MEMORANDUM

SUBJECT: SP20-131 Site Plan – Planning Review 1

LOT 6 PARKER AND PINE EVERBROOK ACADEMY SITE PLAN

COVER SHEET

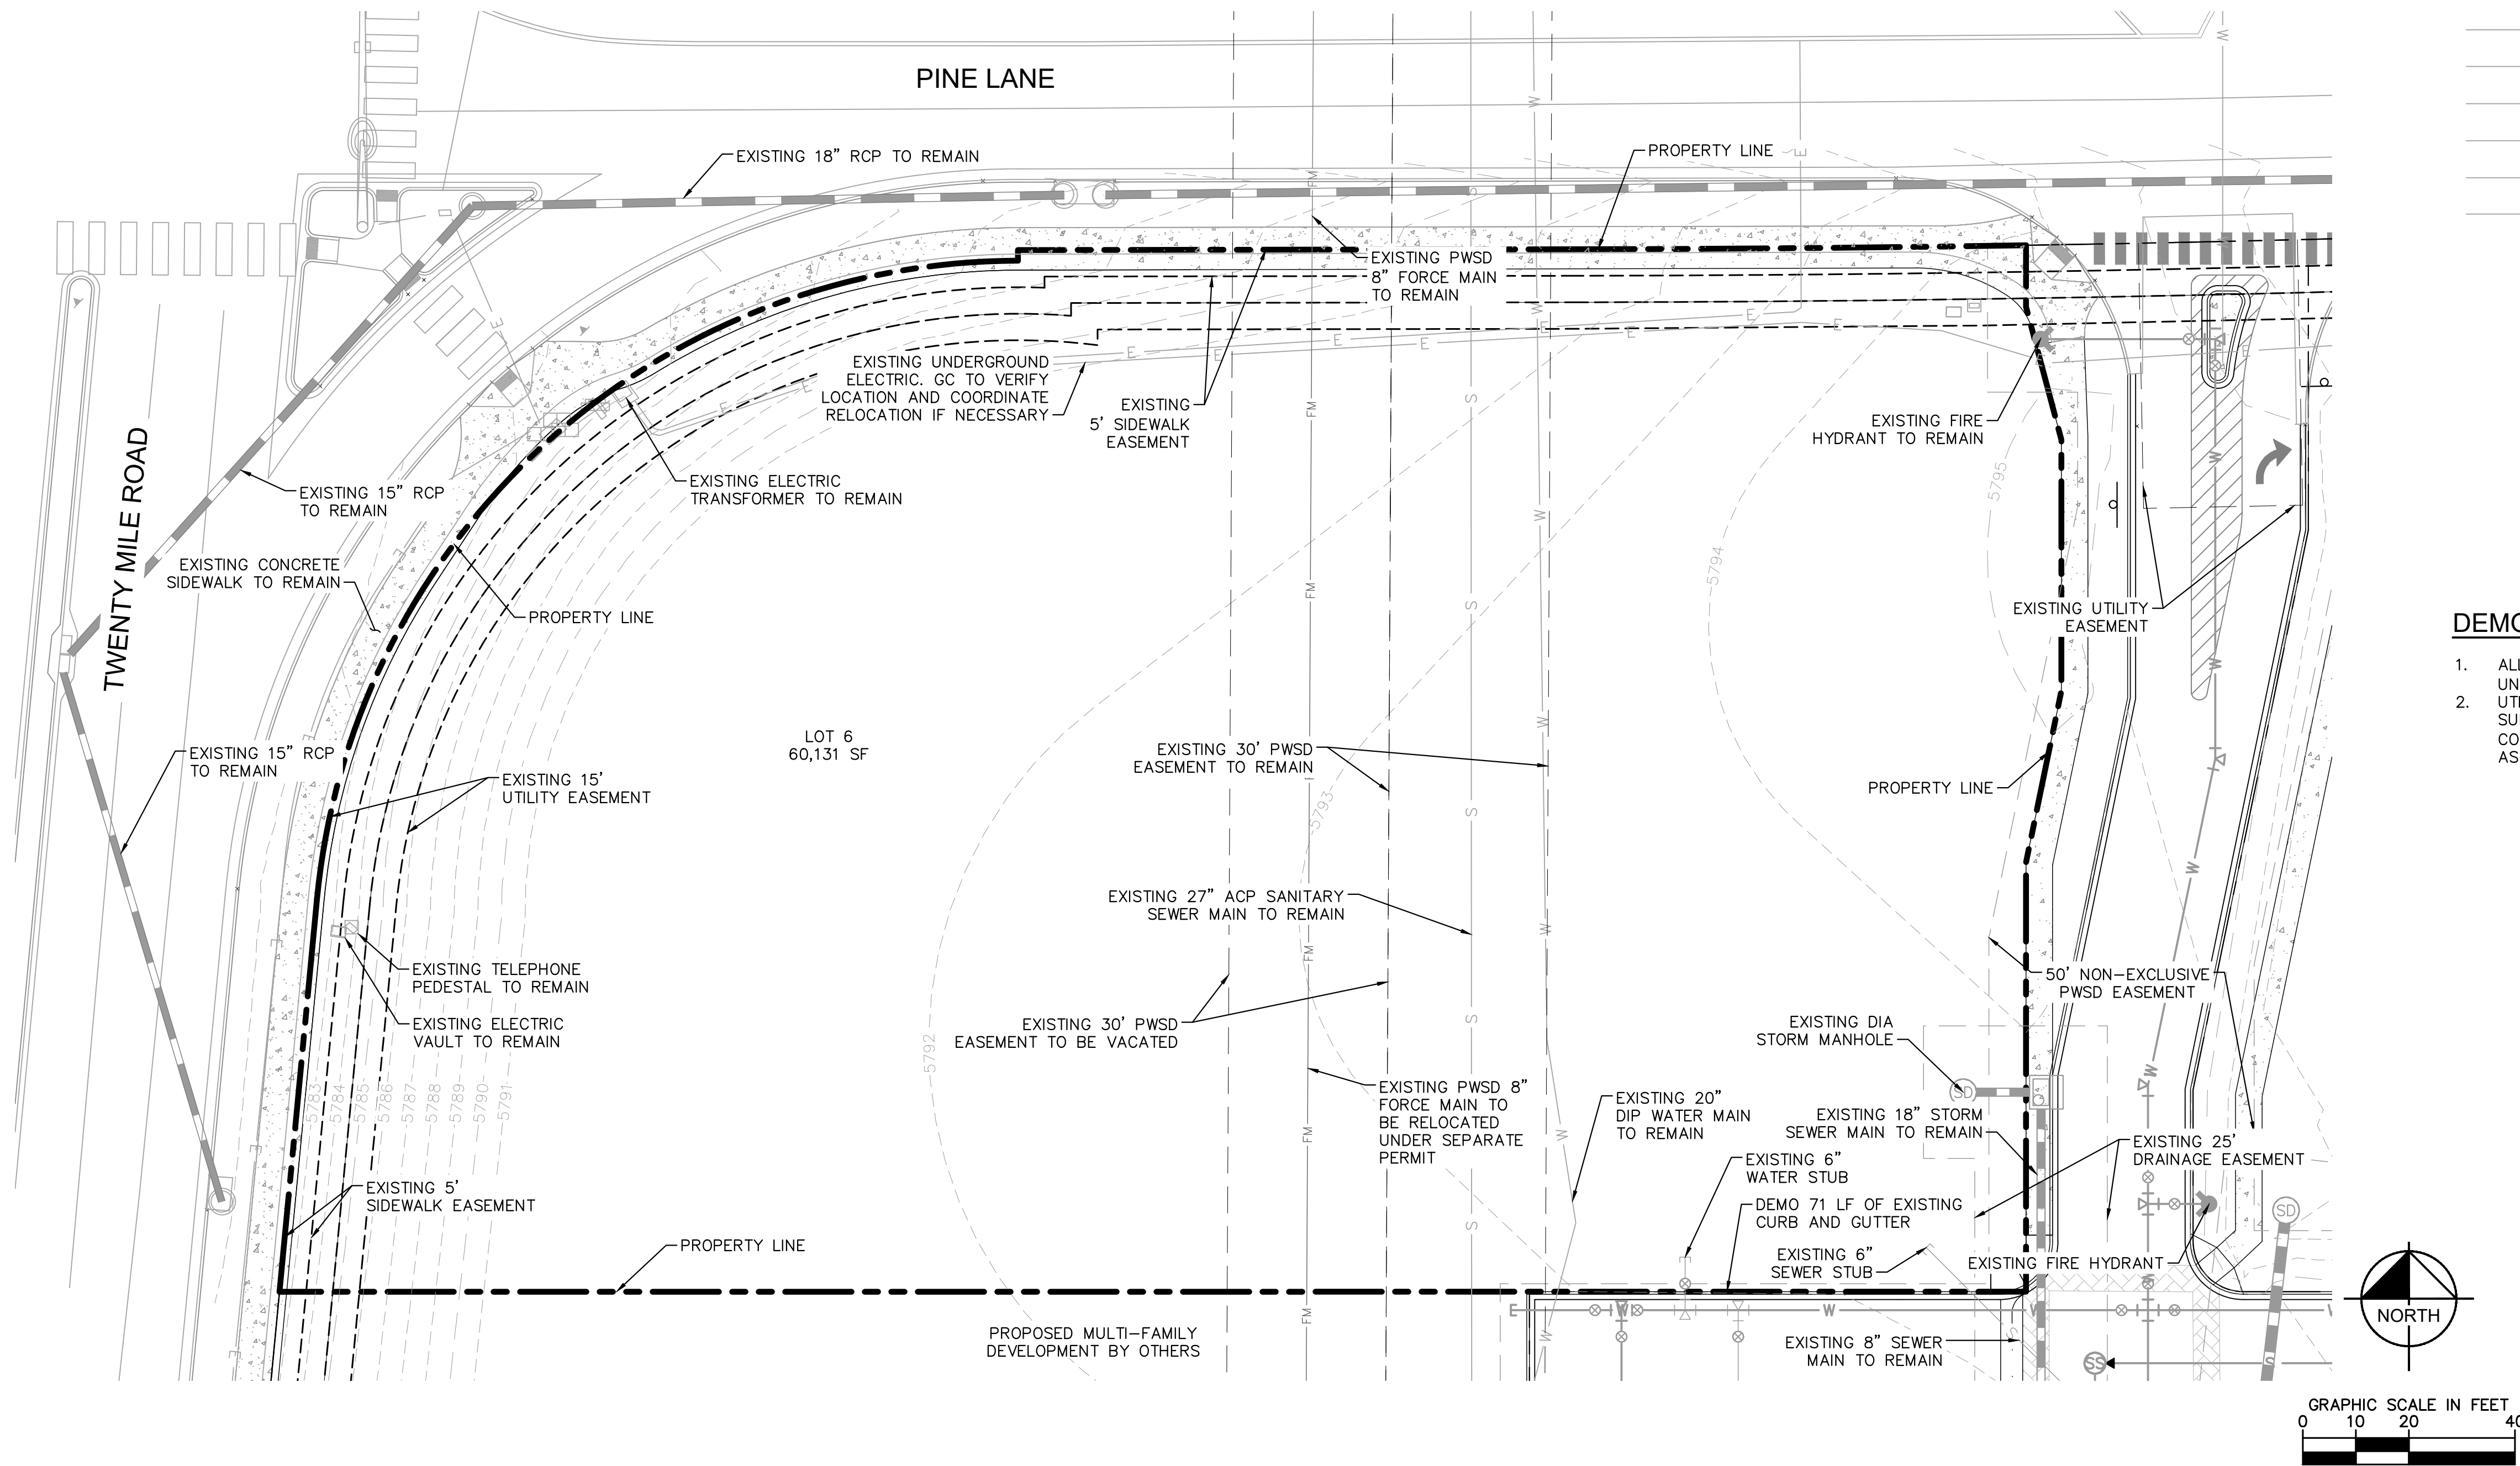
Based on 1 per each
4 children of licenses
capacity. List
maximum number of
children daycare will
supervise.

Add sheet with playground layout
and equipment details.

Add separate sheet for site
circulation and parking. Include
data tables. Show parking, ADA
requirements, bike parking,
sidewalks, ada ramps, crosswalks,
stairs.

Minimum 3 bike parking
spaces required.

Note added.

4 spaces are being
provided.

LOT 6 PARKER AND PINE FILING 1
PARKER, CO
EVERBROOK ACADEMY SITE PLAN
GRADING PLAN

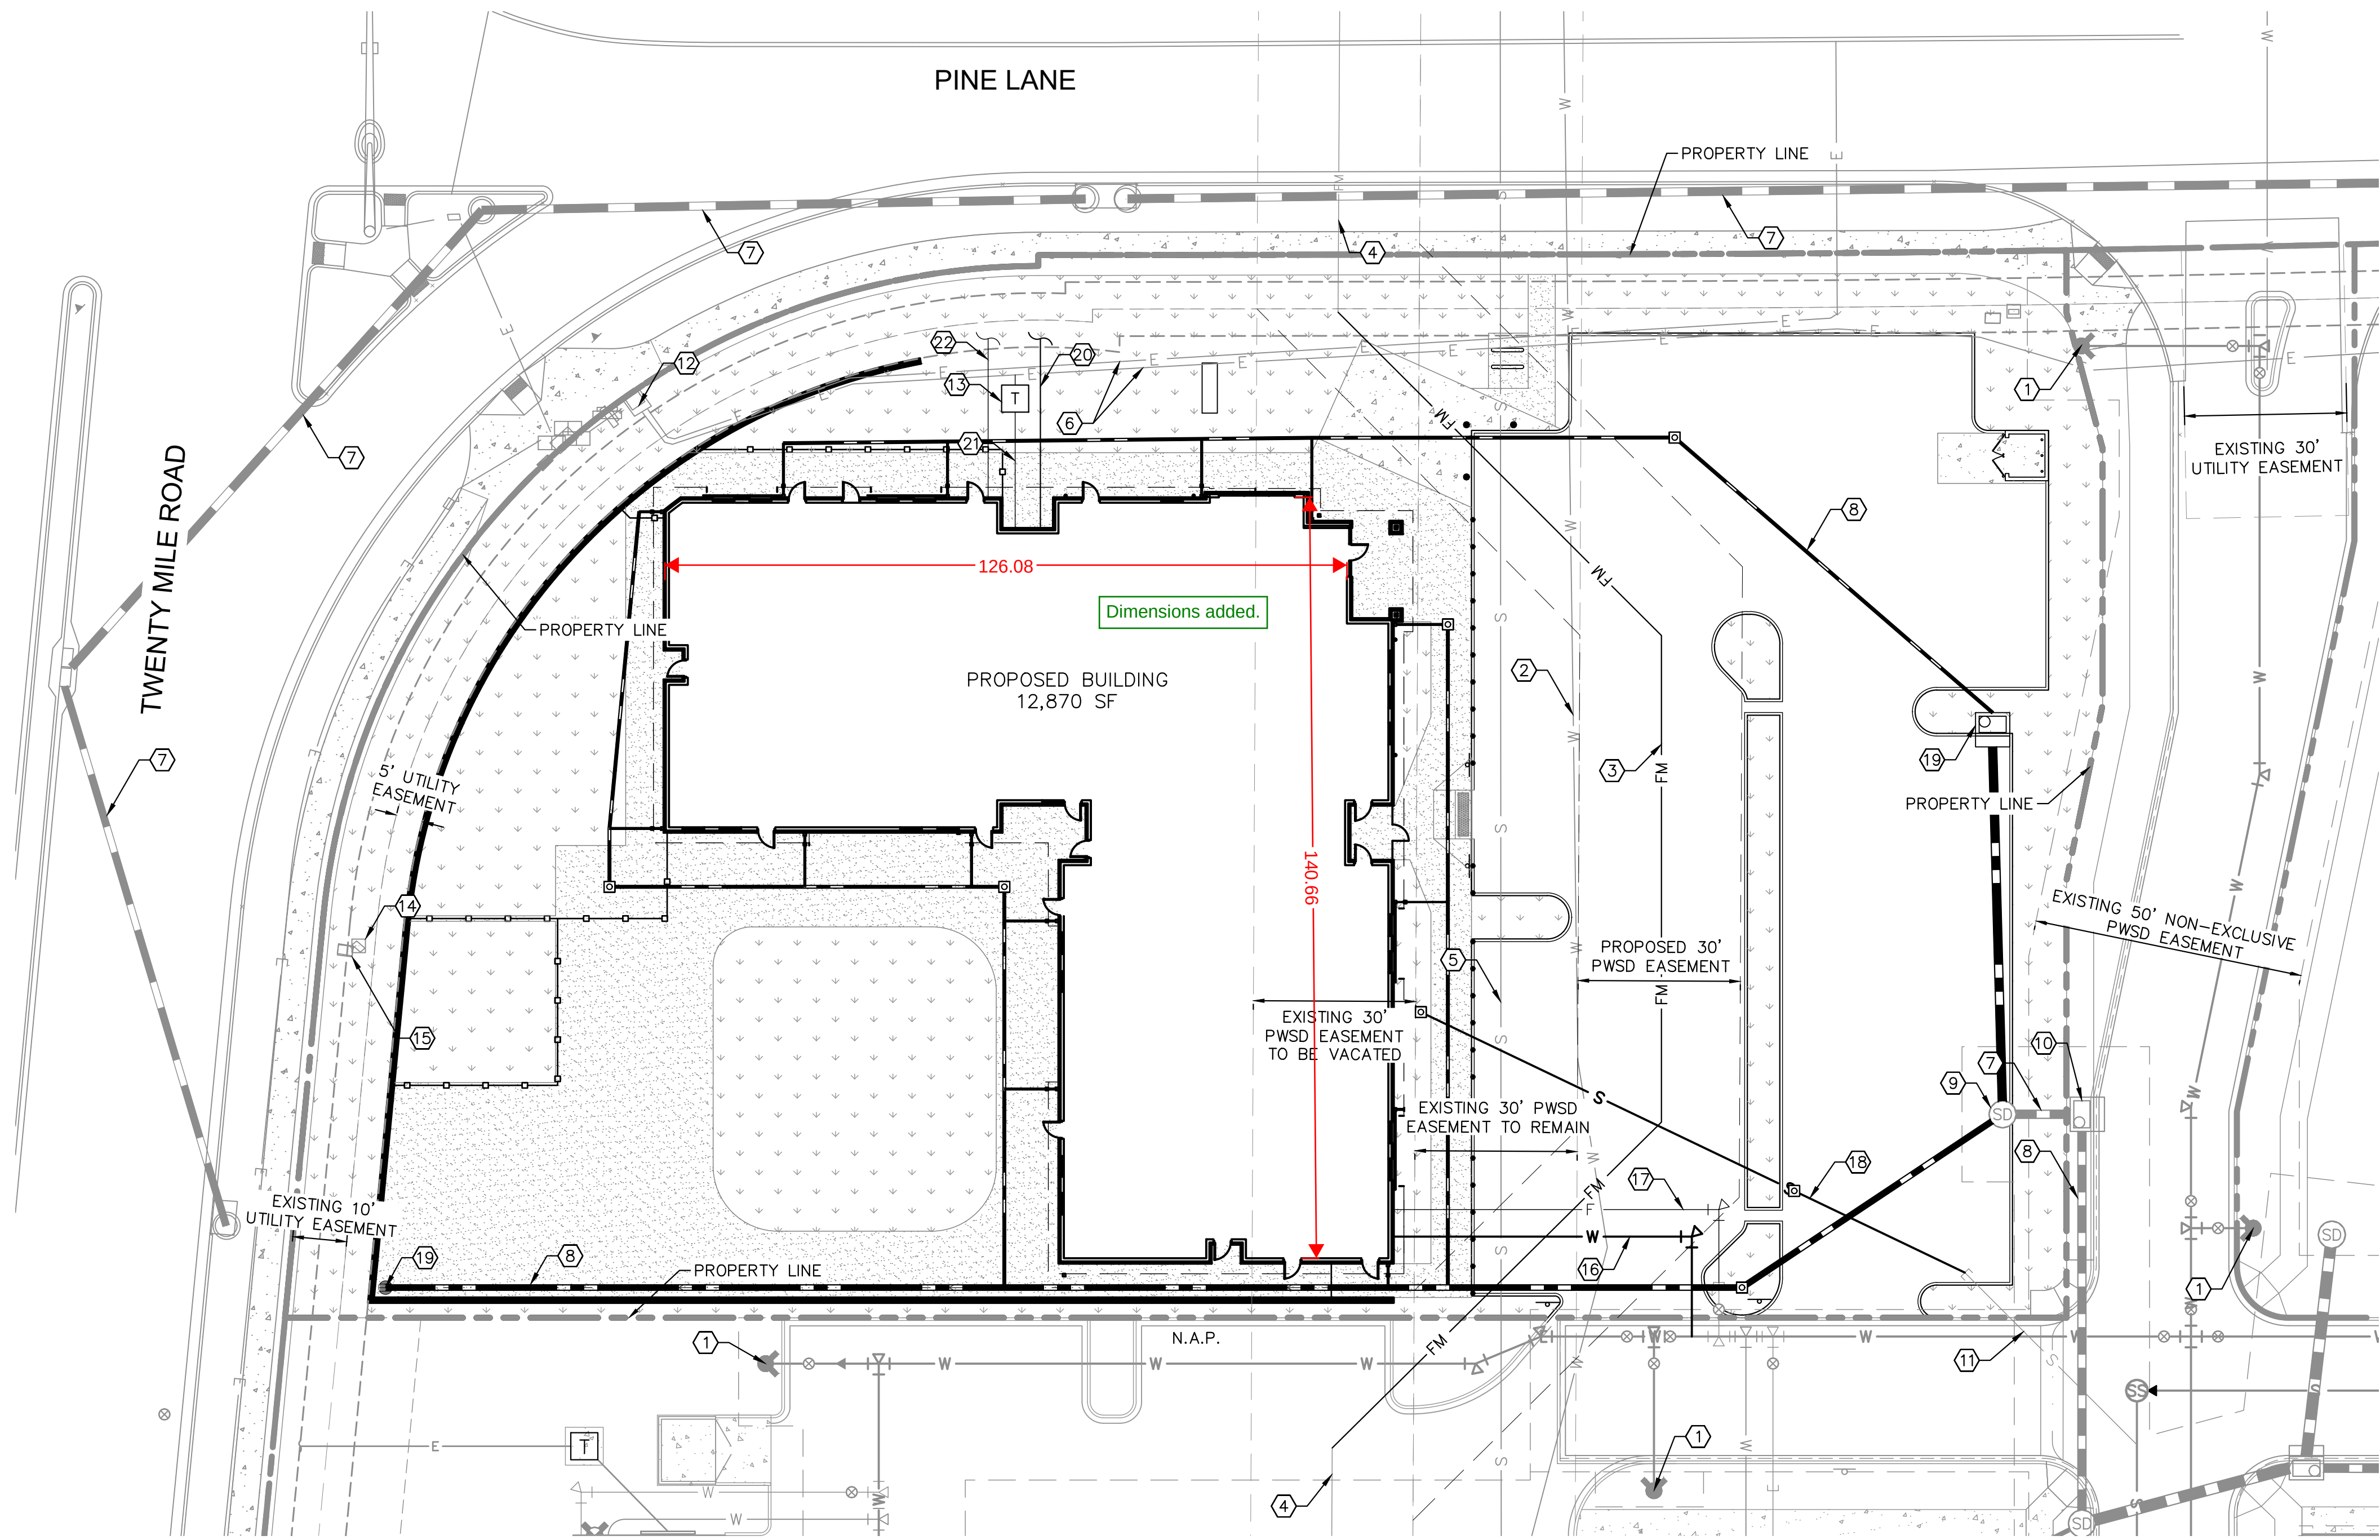
Above 4', a building permit is required for a retaining wall. Provide elevations and materials for wall.

You're putting a retaining wall along this edge? There doesn't appear to be any elevation change. Or has this transitioned to being a fence here? Please clarify. Label line type, add to legend. Create two separate line types for the wall and fence if they are not joined the entire length of both.

Acknowledged.

Retaining wall callout updated to clarify. Wall line type added to legend.
